LASER INTERFEROMETER GRAVITATIONAL WAVE OBSERVATORY  
- LIGO -  
CALIFORNIA INSTITUTE OF TECHNOLOGY  
MASSACHUSETTS INSTITUTE OF TECHNOLOGY

<b>Technical Report</b>	<b>LIGO-T040069-01-E</b>	2004/04/19
<b>Software Review for the GRB030329 Analysis</b>		
Teviet Creighton and Peter Shawhan

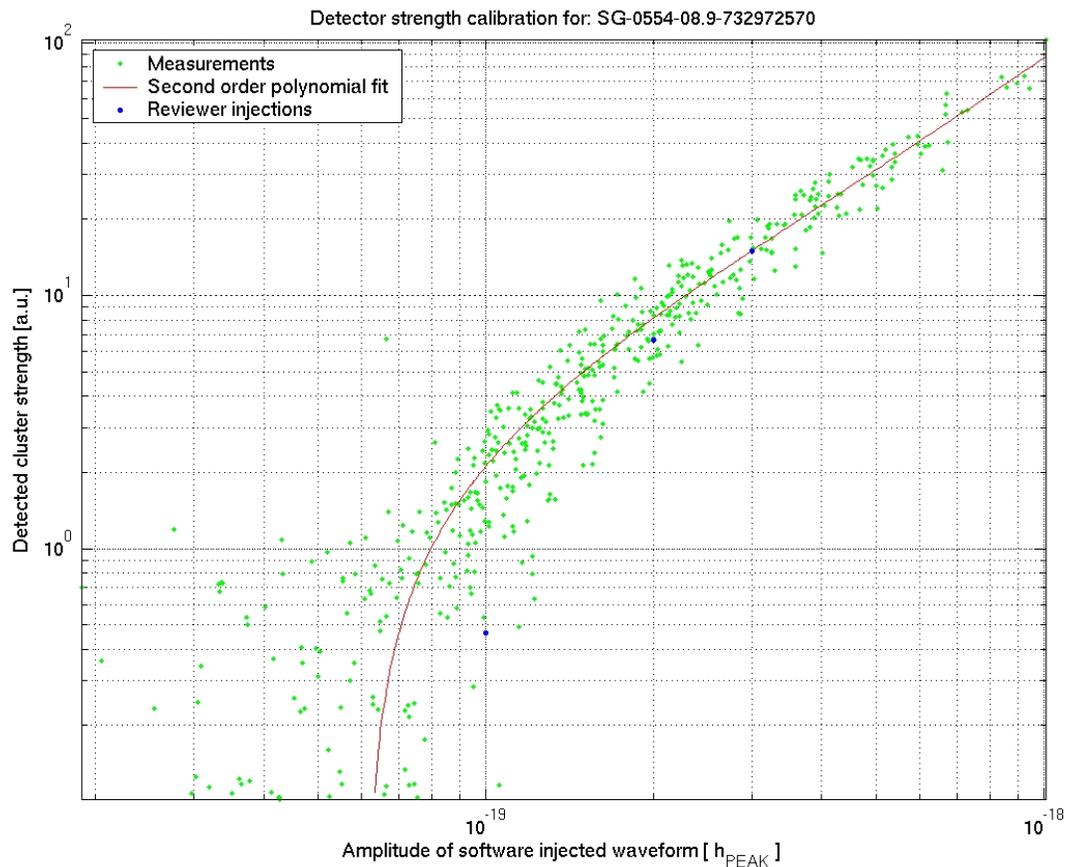
Note that the  $1 \times 10^{-19}$  waveform is at the ragged edge of detectability above noise, which is why the expected cluster strength spans such a large range. Expected cluster strengths were measured by hand from the calibration plot produced by the code. This plot is given below, with the code’s own Monte-Carlo injections shown in green and the three independent injections shown in blue:

From the graph it appears that the independent injections also appear systematically lower in amplitude, though not by any extreme amount: they still lie within the range of the Monte-Carlo calibration. These few “by-hand” injections were not intended to produce an independent calibration, but only to verify that the MATLAB software was not obviously doing anything wrong in its calibration. The code passed this test, so the reviewers feel confident that the results of the code are trustworthy, to within the purported precision.
